INDIANA DEPARTMENT OF ENVIRONMENTAL MANAGEMENT
We Protect Hoosiers and Our Environment.

Re: NPDES Permit No. IN0000108
BP Products North America
Whiting, Indiana Lake County

STATE OF INDIANA
DEPARTMENT OF ENVIRONMENTAL MANAGEMENT
AUTHORIZATION TO DISCHARGE UNDER THE
NATIONAL POLLUTANT DISCHARGE ELIMINATION SYSTEM

BP PRODUCTS NORTH AMERICA, INC.
WHITING REFINERY

Figure 3: Refinery Flow Diagram

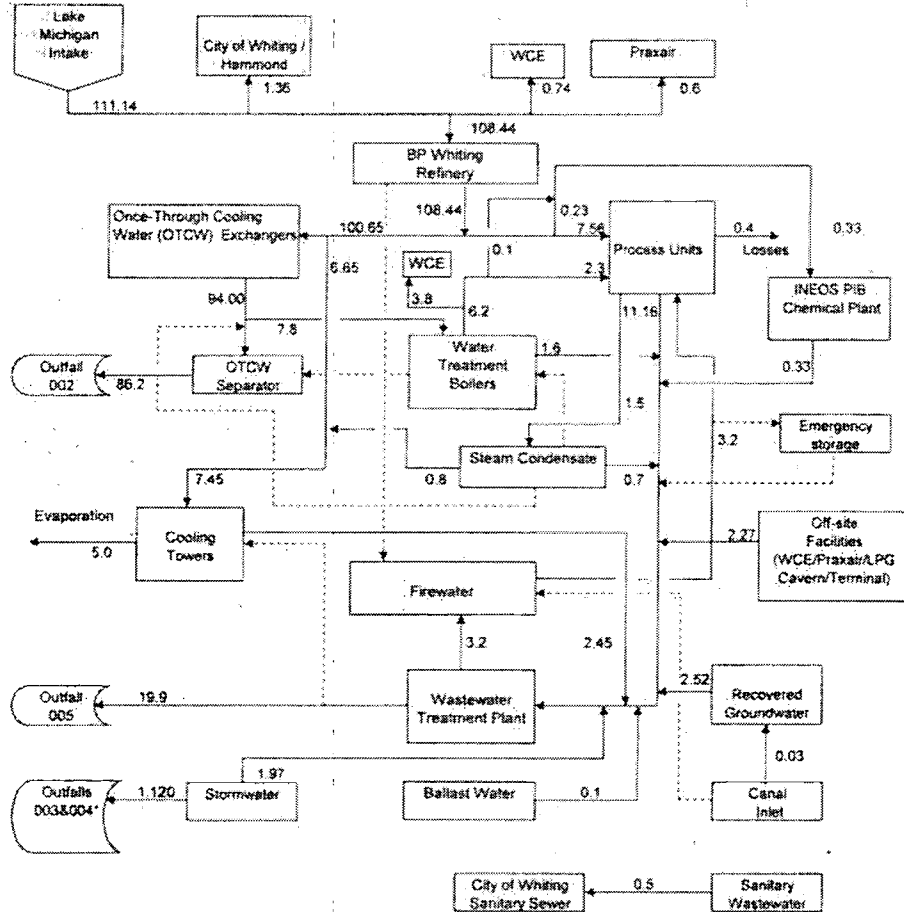
An additional application data element shows in a Water Flow Diagram contained in Applicant's NPDES renewal submittal and shown as Exhibit 9. This sheet identifies a maximum monthly average of daily flow to be 111.14 MGD.

An additional application data element shows in a Water Flow Diagram contained in Applicant's NPDES renewal submittal and shown as Exhibit 9. This sheet identifies a maximum monthly average of daily flow to be 111.14 MGD.
